ADDENDUM NO. 2

Date: August 26, 2021
Project Name: Airfield Marking Rehabilitation for the Jack Brooks Regional Airport
Owner: Jefferson County, Texas
Owner Project No.: IFB 21-052/JW
Garver Project No. 20A12502

RUNWAY 16-34
MARKING REMOVAL
PLAN II

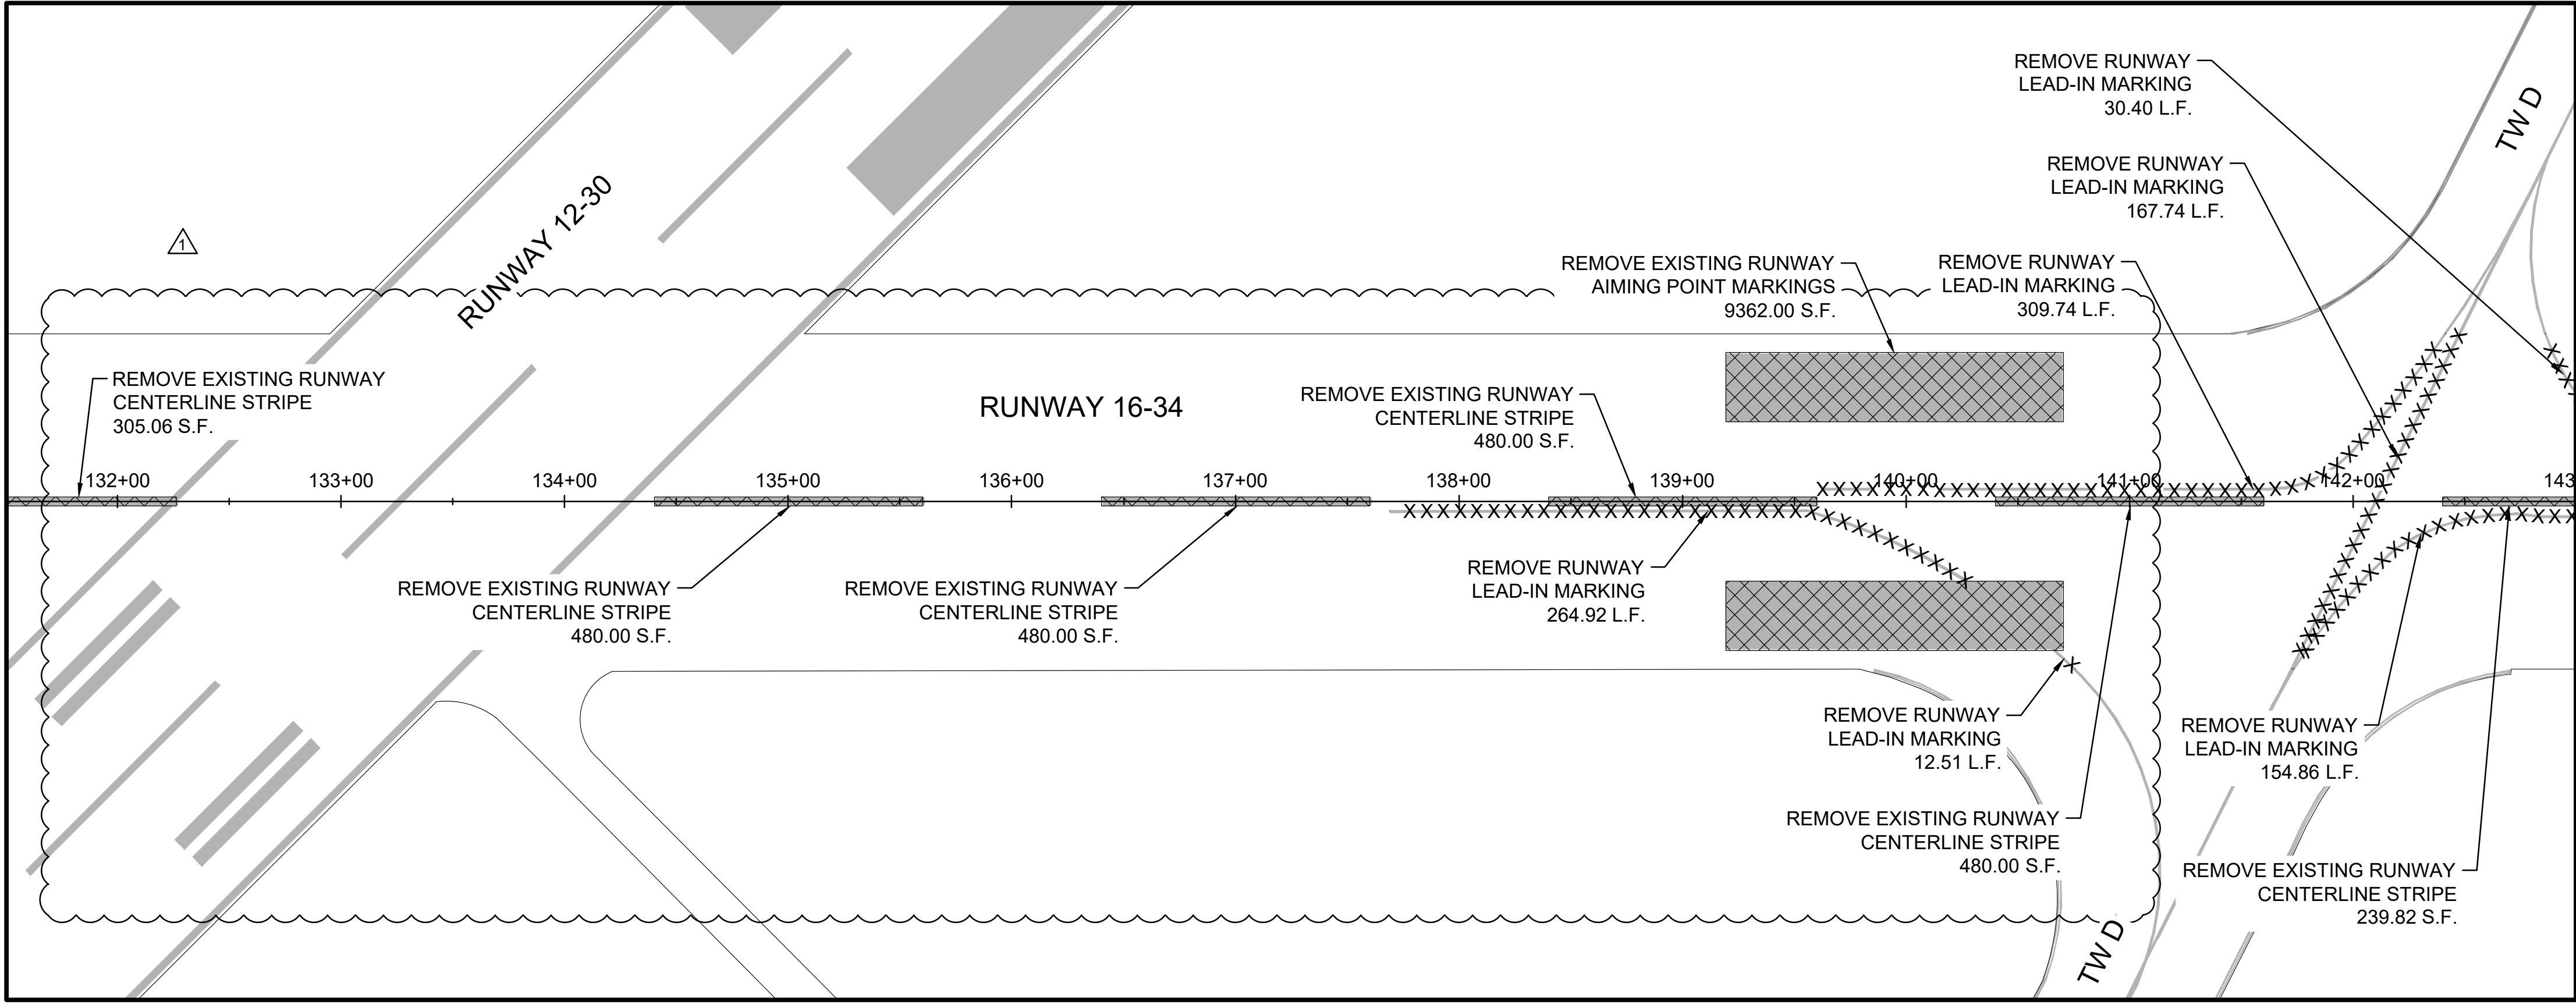
- f. According to Google Earth, the runway centerlines are 120 ft by 3ft for the white. On the plan sheets it says 120 ft by 18". What are the current centerlines measured at?

- g. How did you determine the square feet measurement of 433.55 on the centerlines? What measurements did you use?
 - i. The removal quantity for the existing runway centerline markings has been corrected (see section B below) to 480 SF in this addendum. This accounts for the 120 ft by 3 ft of white markings with the 0.5 ft black outline.

- i. The existing runway centerlines are 120 ft by 3 ft. The proposed runway centerlines will be 120 ft by 1.5 ft white paint with 0.5 ft black outline. The removal quantity for the existing markings has been updated (see section B below) in this addendum.

- 1. Remove the following drawings in their entirety, and replace with the same, attached hereto:
 - a. M-101 RUNWAY 16-34 MARKING REMOVAL PLAN I
 - b. M-102 RUNWAY 16-34 MARKING REMOVAL PLAN II
 - c. M-103 RUNWAY 16-34 MARKING REMOVAL PLAN III

RUNWAY 16-34
MARKING REMOVAL
PLAN III

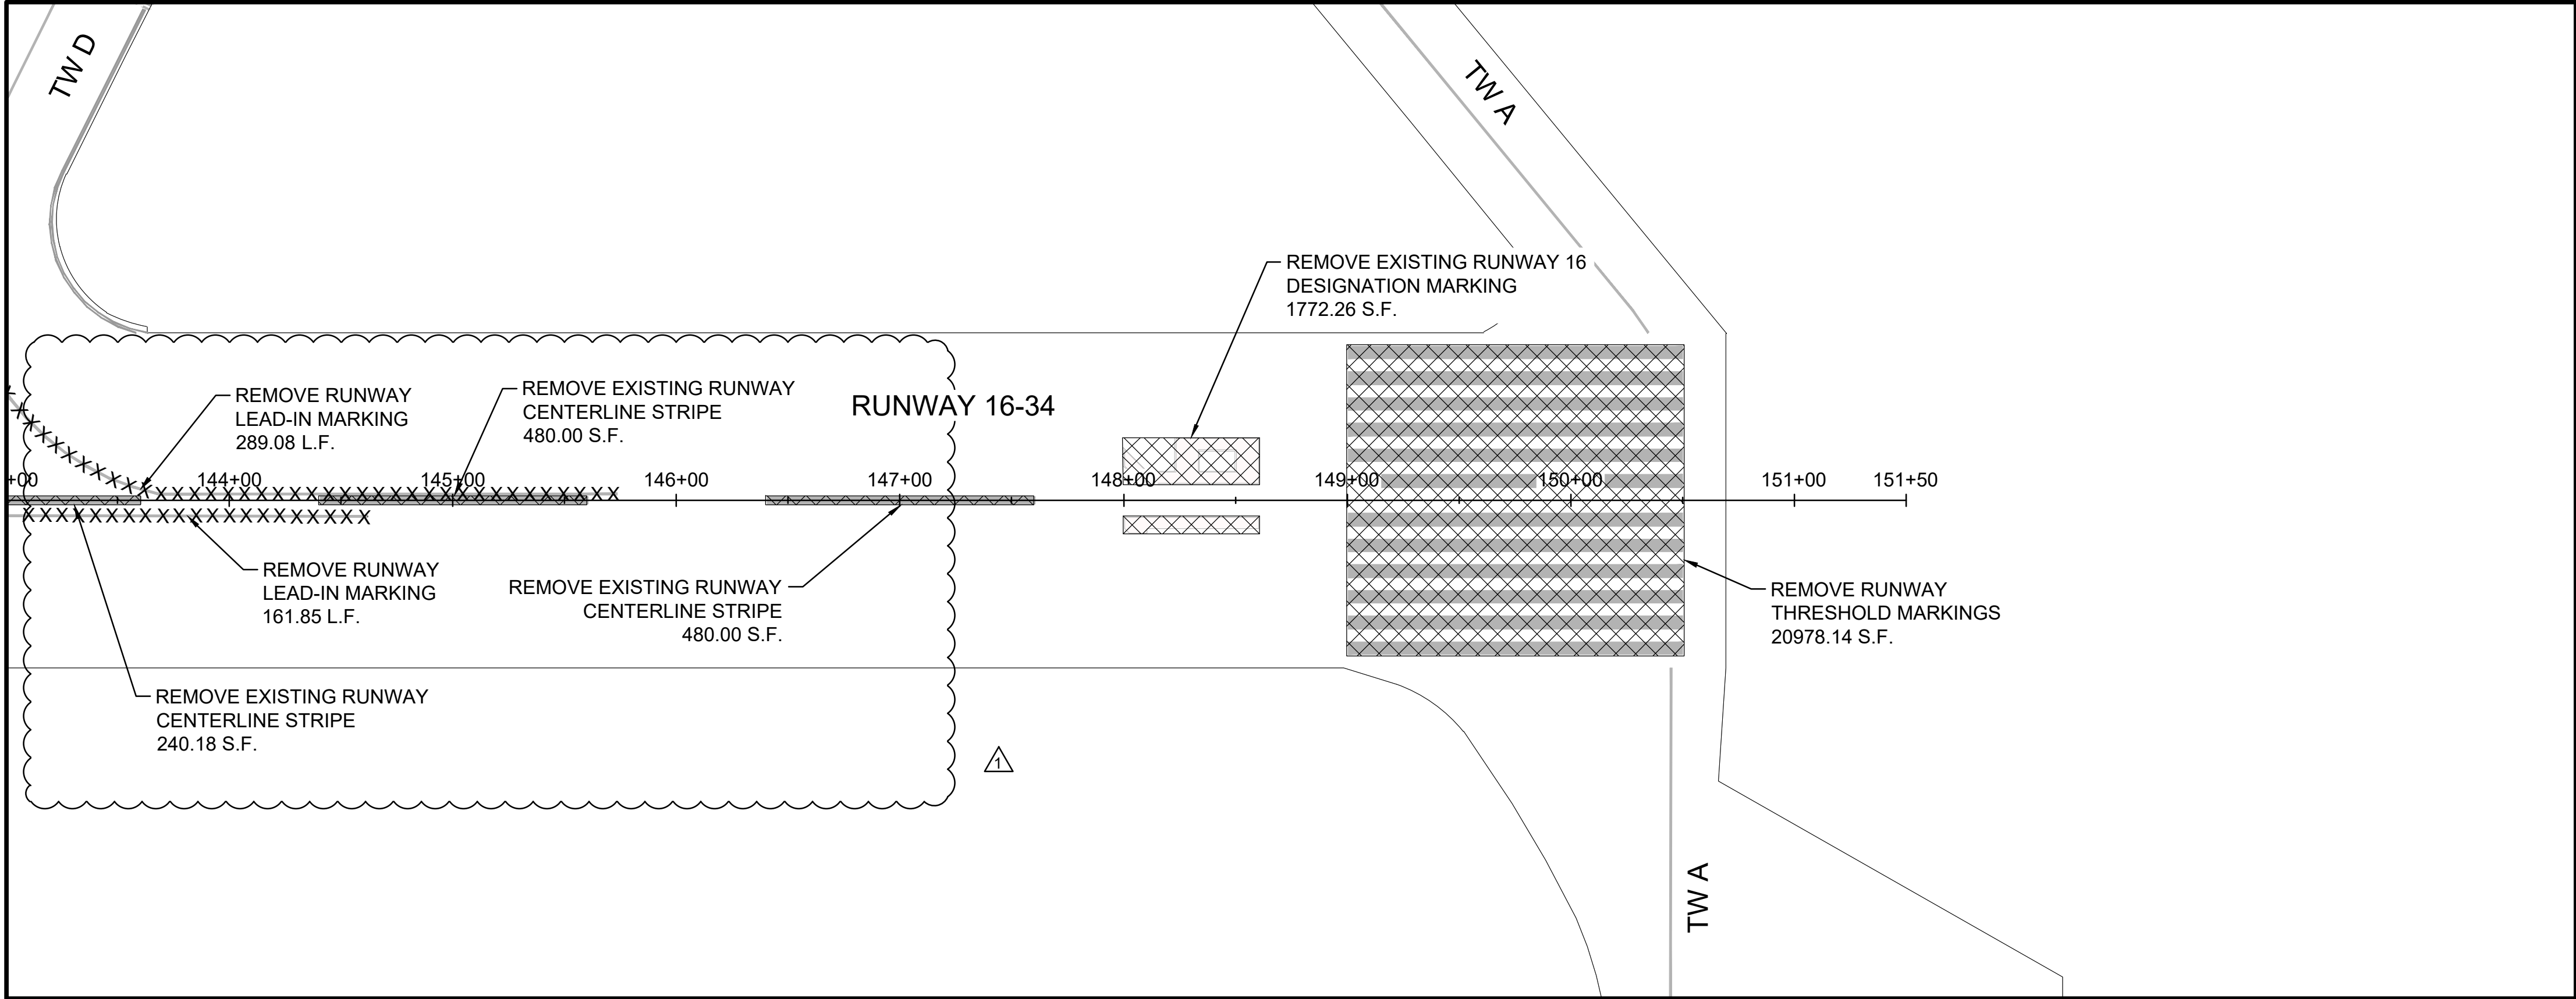
- h. How did you determine the square feet measurement of 9359.52 on the aiming point? What measurements did you use?
 - i. The removal quantity for the existing aiming point markings has been corrected (see section B below) to 9362 SF in this addendum. This accounts for the 150 ft by 31 ft of white markings with the 0.5 ft black outline for the pair of markings.
